SCHEDULE A: Applications with Recommendation

22/0034 TPO

Item No: 02	Date of	Committee: 24/03/2023
Appn Ref No: 22/0034 TPO	Applicant: Citadel Homes	Parish: Stanwix Rural
	Agent: Westwood Landscape Ltd	Ward: Stanwix & Houghton
Location: (Plots 6 & 8) La	nd at Lansdowne Close, Car	lisle, CA3 9HN
Proposal: Pollard 1no. As To 1no. Oak &	h Tree to 5m, Crown Raising 1no. Ash Tree	By 10% Canopy Volume
Date of Receipt: 28/11/2022	Statutory Expiry Date 26/01/2023	26 Week Determination

REPORT

Tree T6 (group 1 tree A in TPO 288) viewed from the adjacent field with the newly constructed houses behind and the large limb lying as a result of previous storm damage.

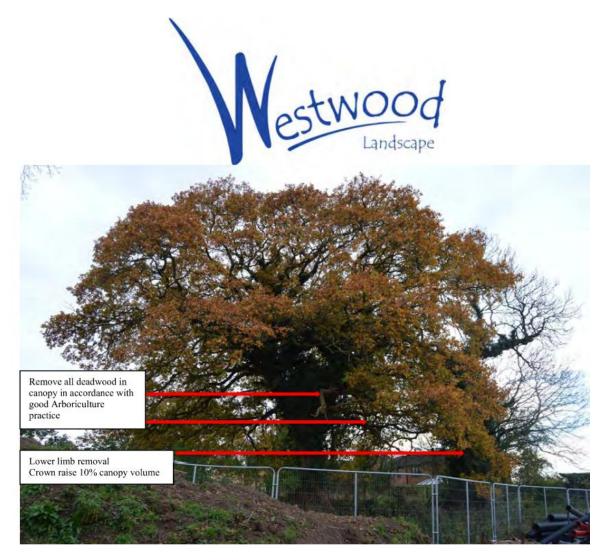
Tree T6 (group 1 tree A in TPO 288) showing the extensive basal decay. Work to be done by a qualified Arboriculture Contractor and tree carefully reduced to a single stem 5m above ground level to minimise risk to adjacent properties. Work in accordance with the report by James England dated 4th January 2023 commissioned by Carlisle City Council.

1. The ash tree T6 (Group G1-A of TPO 288) shall be pollarded to no lower than 10 metres in height.
